CALVERT CLIFFS NUCLEAR POWER PLANT

SUBJECT: Calvert Cliffs Nuclear Power Plant
Unit Nos. 1 & 2; Docket Nos. 50-317 & 50-318
Independent Spent Fuel Storage Installation Docket No. 72-8
Changes to the Emergency Response Plan Implementing Procedures

ERPIP-730

Revision 00105

ATTACHMENT 1, Calvert Memorial Hospital Radiation Emergency Area

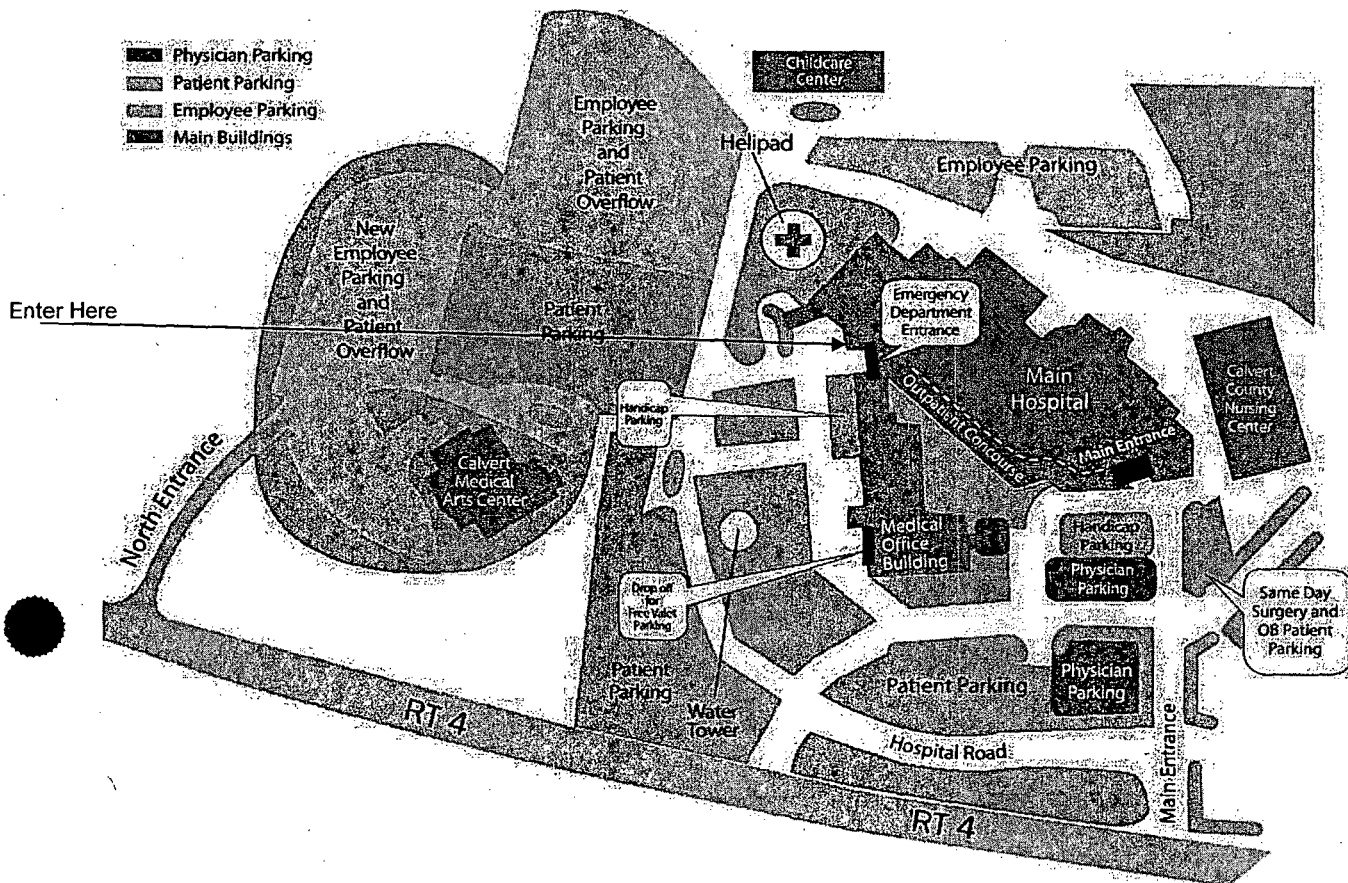
Revision	Change	SUMMARY OF ALTERATIONS Summary of Revision or Change
04		<p>Entire Procedure – Previous change bars have been removed to prevent human error.</p> <p>Entire Procedure – Changed “CEG” and “CE” to “CENG”</p> <p>1.0 – Changed “attending an” to “supervising the care to an”</p> <p>6.1.1 – Bullet 3 – Changed “Barriers” to “Postings and Barricades” (PCR-10-03273)</p> <p>6.1.5 – Added “Electronic Personal Dosimeter (EPD)” (PCR-10-03273)</p> <p>9.0 – Deleted the steps in this section because there are no records generated from this procedure.</p> <p>Attachment 1 – Updated the map for the Radiological Emergency Area at Calvert Memorial Hospital. (PCR-10-03273)</p>
05		Updated map for Calvert Memorial Hospital
